# SERVICE INSTRUCTIONS

No. 0874, Rev. I  
ATA Code 24-00

Kit No. 23-3006-1 S

**SUBJECT:** ELECTRICAL POWER - REPLACEMENT OF VOLTAGE REGULATOR AND OVERVOLTAGE RELAY

FIGURE 1

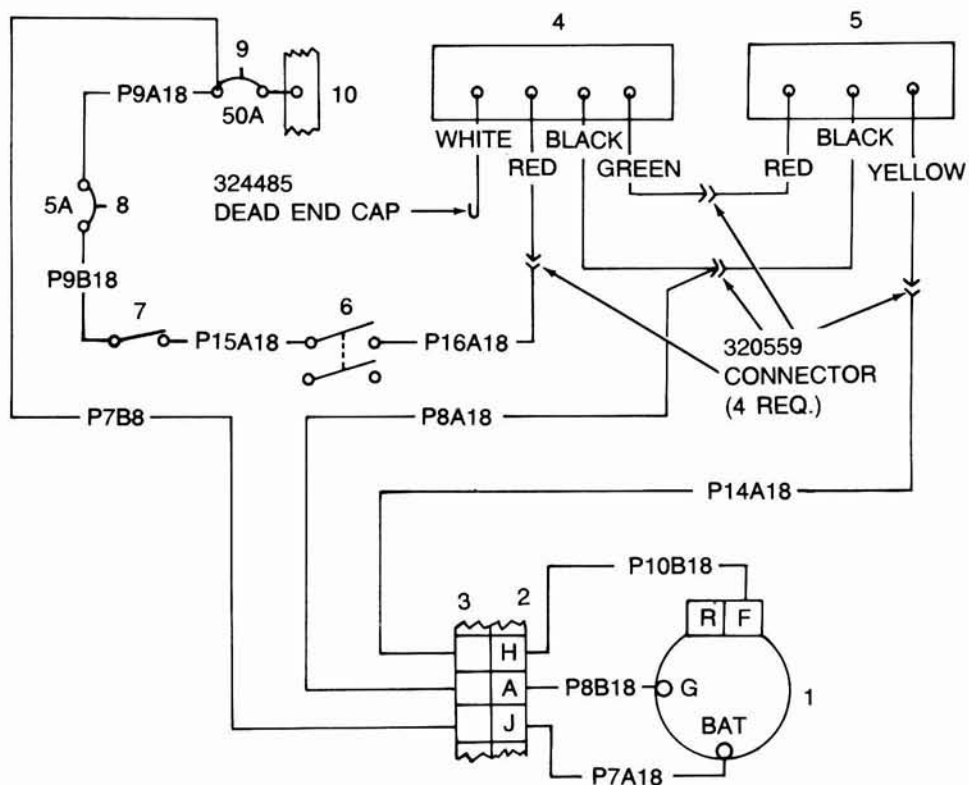
1. Turn off and/or disconnect all electrical power and disconnect the battery.
2. Disconnect the wiring from the existing voltage regulator and the overvoltage relay on the aft side of the engine firewall. Remove the mounting hardware and remove the regulator and relay. Retain all attaching hardware.
3. Ream the mounting holes in the base of the new P/N B00339 overvoltage relay to 3/16-inch diameter.
4. Cut the existing wire terminals from the ends of the wires on the new overvoltage relay.
5. Install the new voltage regulator and overvoltage relay on the firewall with the existing attaching hardware.
6. On airplanes listed under PART I of the EFFECTIVITY section, refer to Figure 1 and complete the following:

- a. Connect the green wire from the overvoltage relay to the red wire from the voltage regulator using a P/N 320559 connector.
- b. Connect the black wire from the overvoltage relay, the black wire from the voltage regulator and wire P8A18 together with a P/N 320559 connector.
- c. Remove wire P16A18 from pin H on the firewall receptacle. Reroute the wire as required and connect wire P16A18 to the red wire from the overvoltage relay using a P/N 320559 connector.

- d. Connect wire P14A18 to the yellow wire from the voltage regulator using a P/N 320559 connector.
- e. Remove the other end of wire P14A18 from the alternator switch. Reroute the wire as required and connect wire P14A18 to pin H on the firewall receptacle.
- f. Reroute as required and connect wire P9B18 to the alternator switch using a P/N MS25036-102 terminal.
- g. Remove and discard wire P9C18.
- h. Install a P/N 324485 dead end cap to the white wire from the overvoltage relay and stow the wire.

FIGURE 2

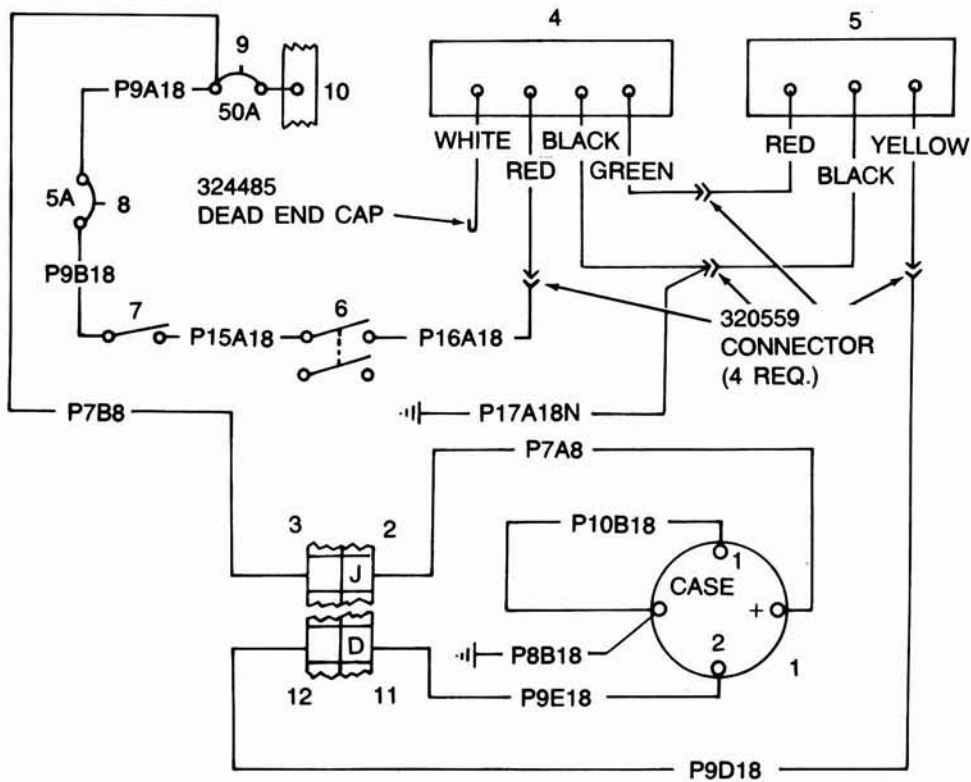
7. On airplanes listed under PART II of the EFFECTIVITY section, refer to Figure 2 and complete the following:

- a. Connect the green wire from the overvoltage relay to the red wire from the voltage regulator using a P/N 320559 connector.
- b. Install a P/N MS25036-103 terminal on one end of the 4-foot section of wire contained in the kit. Identify this wire as P17A18N and attach the terminal to one of the ground terminals on the RH side of the instrument subpanel.
- c. Route wire P17A18N as required and connect the other end to the black wires from the overvoltage relay and the voltage regulator using a P/N 320559 connector.

- d. Remove wire P16A18 from pin H on the firewall receptacle (large). Reroute the wire as required and connect wire P16A18 to the red wire from the overvoltage relay using a P/N 320559 connector.
- e. Connect wire P9D18 to the yellow wire from the voltage regulator using a P/N 320559 connector.
- f. Route as required and connect wire P9B18 to the alternator switch using a P/N MS25036-102 terminal.
- g. Remove wire P10B18 from pin H on the firewall plug (large). Using a P/N MS25036-150 terminal, connect wire P10B18 to the case of the alternator with wire P8B18.
- h. Remove wire P8B18 from pin A on the firewall plug (large). Using a P/N MS25036-150 terminal, attach wire P8B18 to a ground on the engine.
- i. Remove and discard wires P9C18, P8A18 and P14A18.
- j. Install a P/N 324485 dead end cap on the white wire from the overvoltage relay and stow the wire.

FIGURE 3

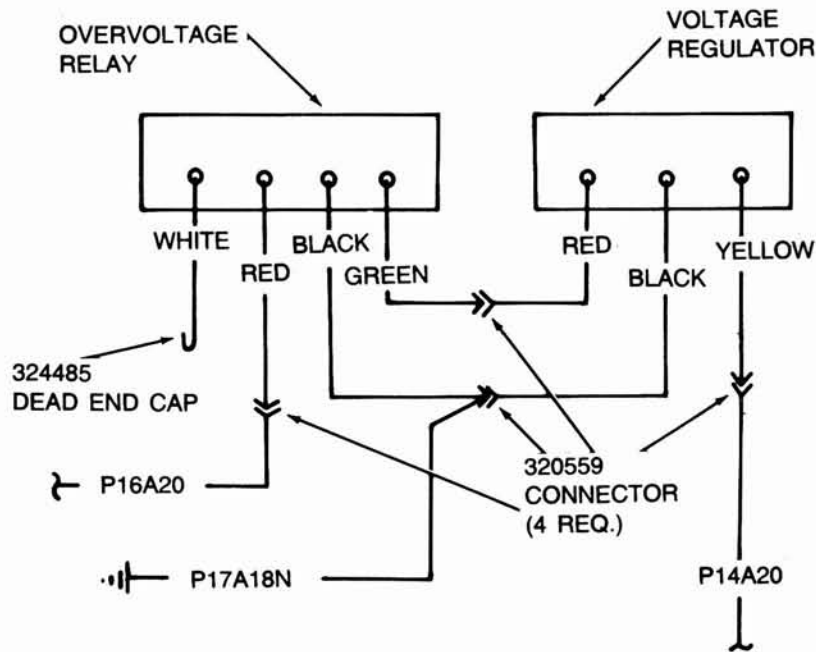
8. On airplanes listed under PART III of the EFFECTIVITY section, refer to Figure 3 and complete the following:

- a. Connect the green wire from the overvoltage relay to the red wire from the voltage regulator using a P/N 320559 connector.
- b. Install a P/N MS25036-103 terminal on one end of the 4-foot section of wire contained in the kit. Identify this wire as P17A18N and attach the terminal to one of the ground terminals on the RH side of the instrument subpanel.
- c. Route wire P17A18N as required and connect the other end to the black wires from the overvoltage relay and the voltage regulator using a P/N 320559 connector.
- d. Connect wire P16A20 to the red wire from the overvoltage relay using a P/N 320559 connector.
- e. Connect wire P14A20 to the yellow wire from the voltage regulator using a P/N 320559 connector.

f. Install a P/N 324485 dead end cap on the white wire from the overvoltage relay and stow the wire.
